*Mixed Oxide Fuel Fabrication Facility
Construction Authorization Request
Responses to NRC Request for Additional Information*

135. Figure 10-1, p. 10-21

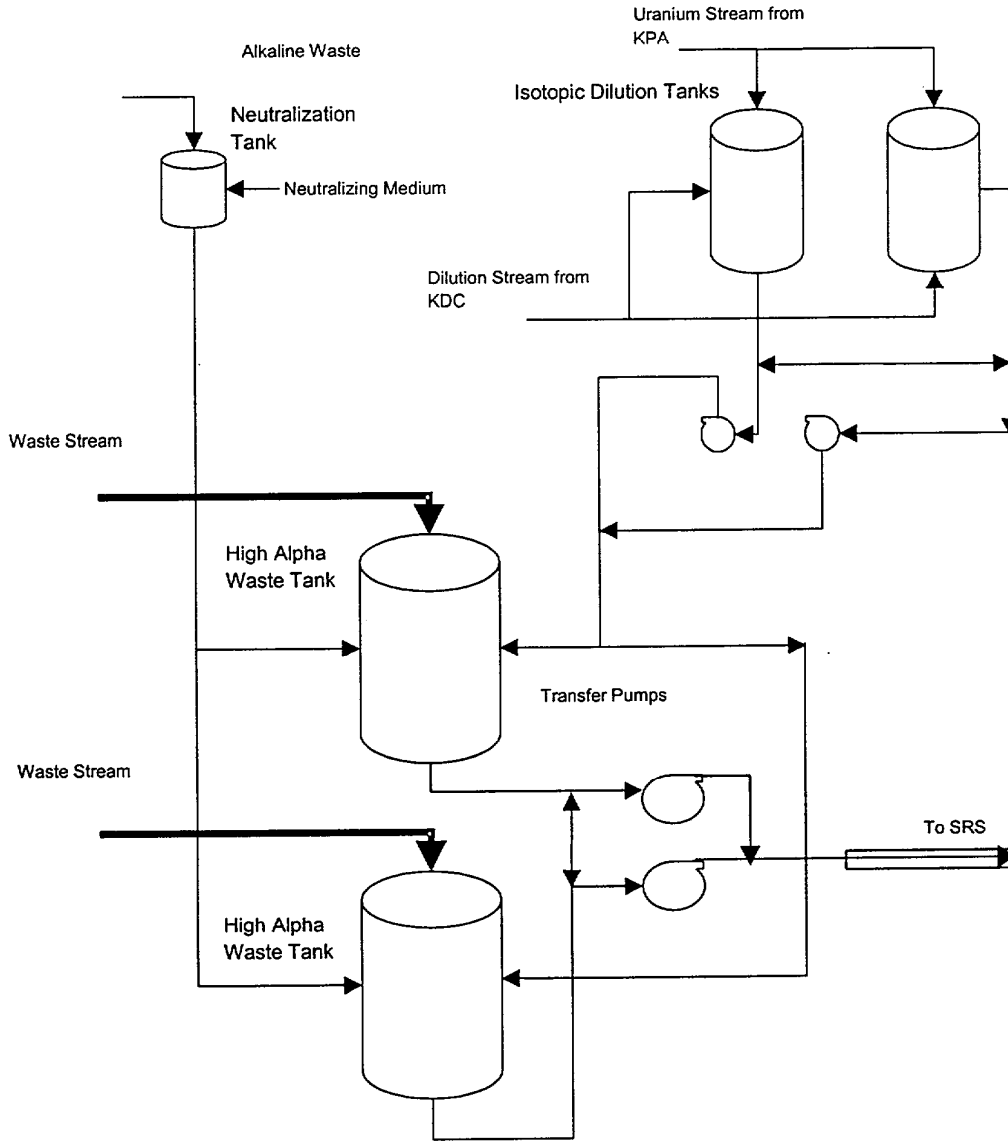
Figure 10-1 depicts the liquid waste streams from aqueous polishing and has a box labeled "High Alpha Waste Buffer Storage." A description of this process area, its design bases, and design basis values could not be found in the associated text in Sections 8.1.1.2.3, 10.1.4, and 11.3.2.12. Such a description is necessary to understand the potential hazards associated with this system, safety issues, and any proposed principal SSCs and IROFSs.

The diluted uranium stream, the acidified alkaline stream, and the rest of the high alpha waste is collected in one of two high alpha waste tanks. While one tank is pumped out, the other collects the high alpha waste. The waste is pumped to SRS for storage and treatment using shielded lines. Level inside the tanks is remotely monitored using level instrumentation. The tank contents are sampled prior to start of transfer to SRS to ensure that they comply with the SRS Waste Acceptance Criteria (WAC). It is anticipated that a communications link between the MOX facility and SRS will be used to receive acceptance from SRS to initiate transfers and to signal end of operation at the end of transfer. These communication link issues will be developed during detail engineering.

The high alpha waste tanks are sized to accommodate a one-week quantity of waste based on 42 operating weeks per year. This corresponds to approximately 1,200 gallons per week. In addition, the tanks are sized to accommodate an equal volume (1,200 gallons) of backwash. Based on a suitable operating margin of 600 gallons, the high alpha buffer tanks are each sized for 3,000 gallons. The isotopic dilution tanks, high alpha waste tanks, and the neutralization tank are all located inside closed cells. The cells will be remotely monitored for radiation levels. Details of radiation monitoring issues will be addressed during detail design.

The high alpha buffer tanks are equipped with one operating and one spare pump. The pumps are each 40 gpm. This allows the transfer of the normal tank contents of 1,200 gallons from one high alpha buffer tank to SRS in 30 minutes. If the tank contents are greater than 1,200 gallons, transfer times will be longer.

Final design of the high alpha waste system will be clarified during the ISA/LA.

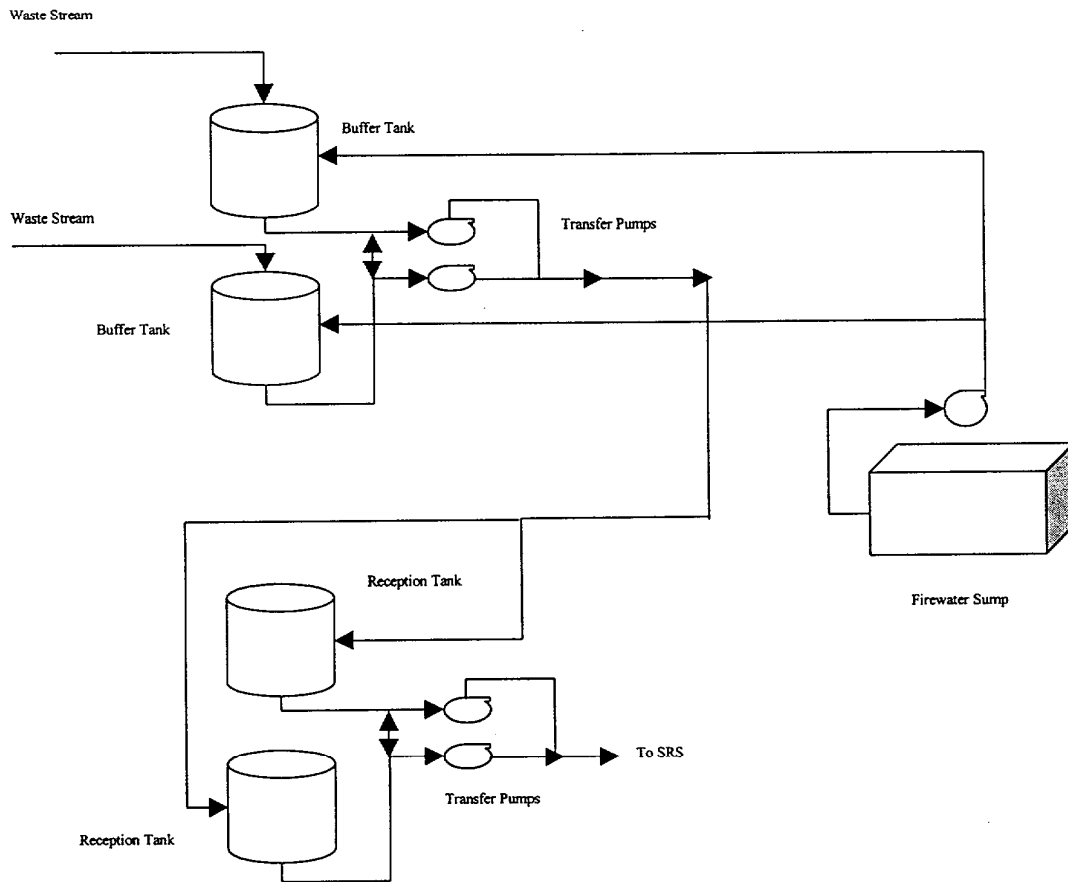
Section 11.3.2.12 mentions a "liquid waste reception unit." There is one sentence that reads, "The Liquid Waste Reception Unit will receive liquid waste from the AP process for temporary storage before sending it to SRS for treatment and processing." Figure 10-1 shows at least two liquid LLW buffer storage areas/units. A description of these areas, their design bases, and design basis values could not be found in the associated text in Sections 8.1.1.2.3, 10.1.4, and 11.3.2.12. Such a description is necessary to understand the potential hazards associated with this system, safety issues, and any proposed principal SSCs and IROFSs.

Additionally, corridor drains from firewater release are first routed to a sump and then transferred to the waste tanks in the KWD; no flow is expected during normal operation.

The aqueous LLW streams are collected in one of two 1,200-gallon capacity tanks in the KWD. The tanks are equipped with an operating and a spare pump that allow transfer downstream but are also connected to permit recirculation of the tank contents. The LLW is fed forward to two 5,000-gallon capacity waste reception tanks. These tanks are also equipped with an operating and a spare pump with similar transfer and recirculation capabilities. After sampling, the LLW from the waste reception tanks is transferred to the SRS process sewer for disposal in the ETF.
